Farleaze Farm Flooding, Railway Drainage and Fosse Way Runoff

I attended Tuesday's hearing but had to leave before the discussion concerning the flood plain at [REDACTED]. I have since reviewed the transcript and wish to make this short written submission.

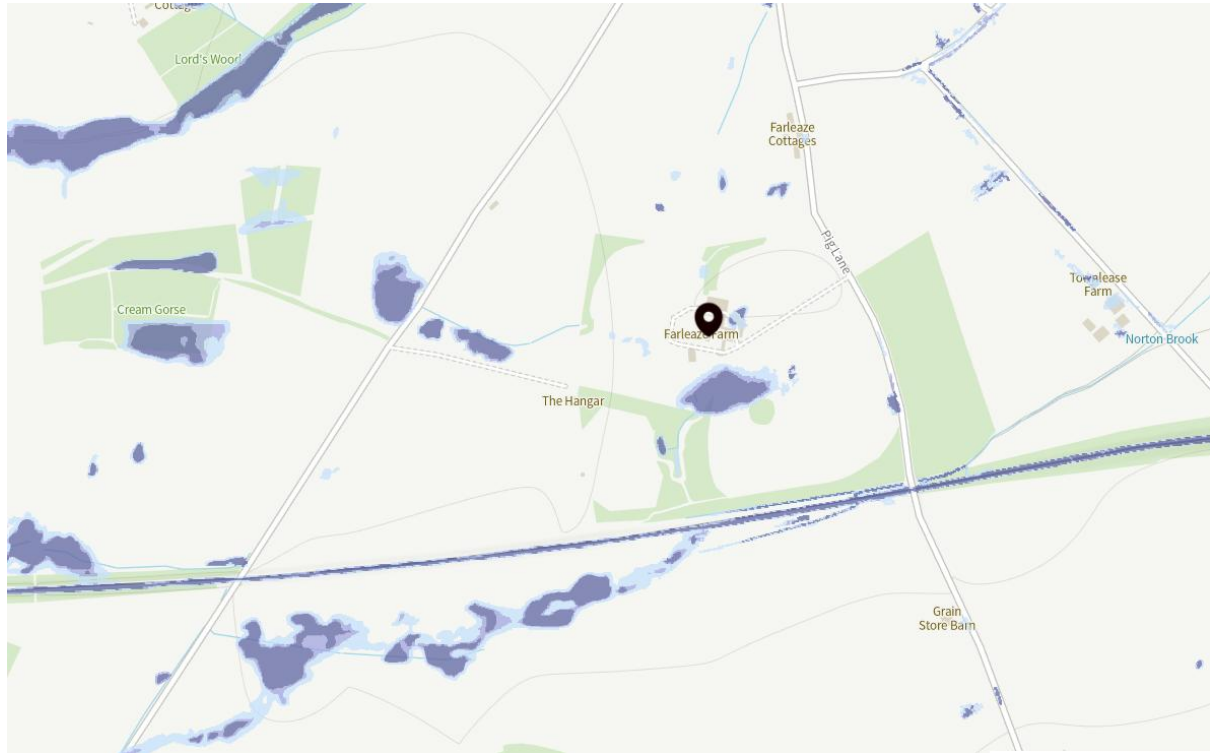
The Examining Authority should therefore be satisfied that the Applicant understands the whole system as it operates **now**: the Fosse Way watershed, the Farleaze flood plain, the railway culverts and drainage, the Norton Brook and Gauze Brook catchments, and Network Rail's current management of its infrastructure.

I respectfully ask the Examining Authority to require the Applicant to confirm this expressly and, if necessary, provide a specific Farleaze drainage note or addendum demonstrating the interaction between:

- the Fosse Way scarp and road drainage;
- the surrounding field catchments;
- the Farleaze flood plain;
- the railway culverts and drainage infrastructure;
- Network Rail's current drainage and asset-management arrangements;
- the Norton Brook and Gauze Brook systems;
- the proposed Lime Down development and construction works; and
- the hydrological monitoring and verification framework.
